CITY OF ALBUQUERQUE

RE: 4801 Valle Rio Tr NW
Grading and Drainage Plan
Engineer's Stamp Date: 11/01/21
Hydrology File: F12D004

Based upon the information provided in your submittal received 10/29/2021, the Grading and Drainage Plan is approved for Grading Permit (earthwork can get started for the earth pad on the house).

Grading and Drainage Plan

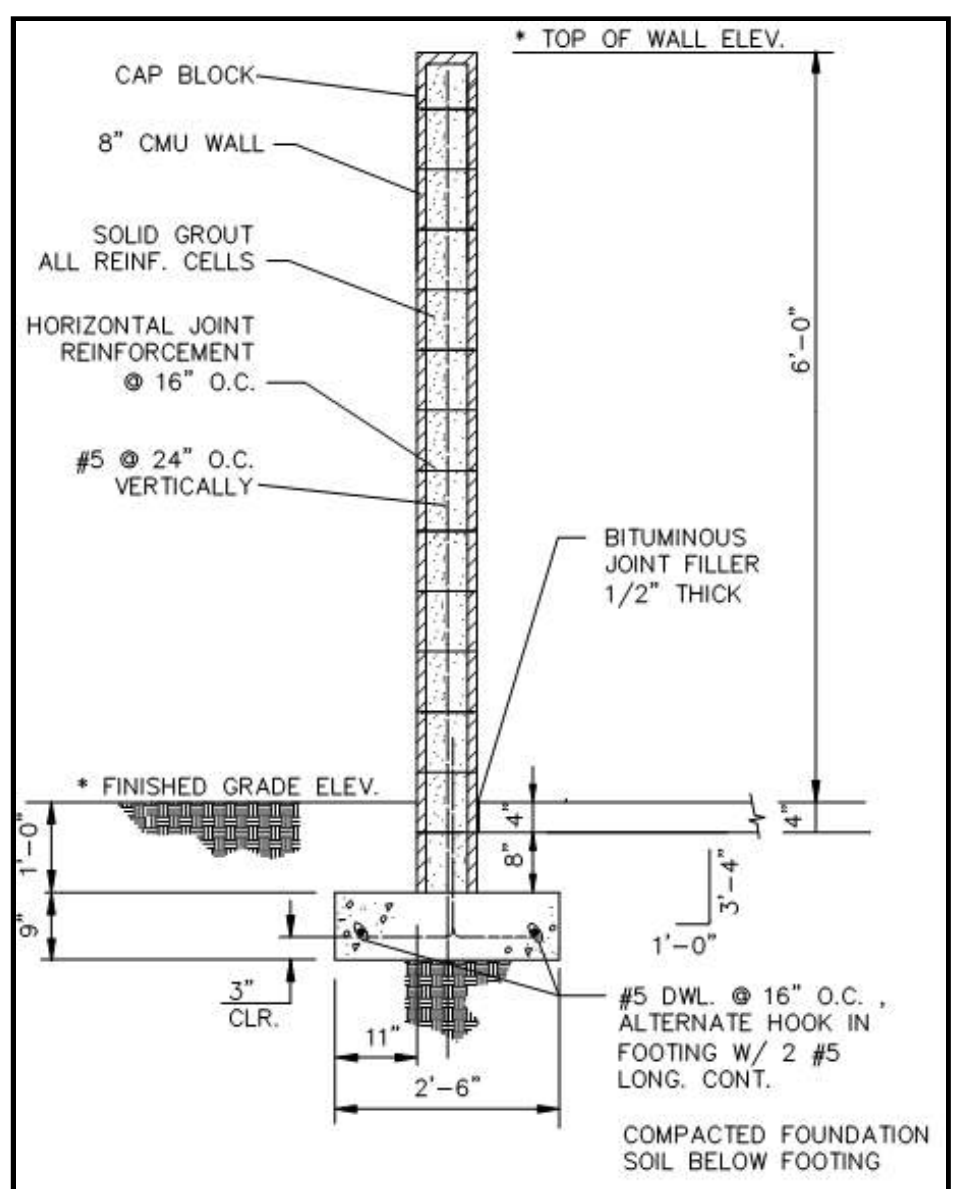
1. Once the grading is complete (the earth pad is done for the house), please attach a site photo with the Hydrology submittal for Pad Certification and Building Permit approval.
2. An Engineer's Certification of the compacted pad and grading (Pad Certification), per the DPM Part 6-14 (G): Engineer's Certification Checklist for Subdivision and Part 6-14 (H): Required Certification Language is required prior to issuing Building Permit.

1. Engineer's Certification, per the DPM Part 6-14 (G): Engineer's Certification Checklist for Subdivision and Part 6-14 (H): Required Certification Language is required.
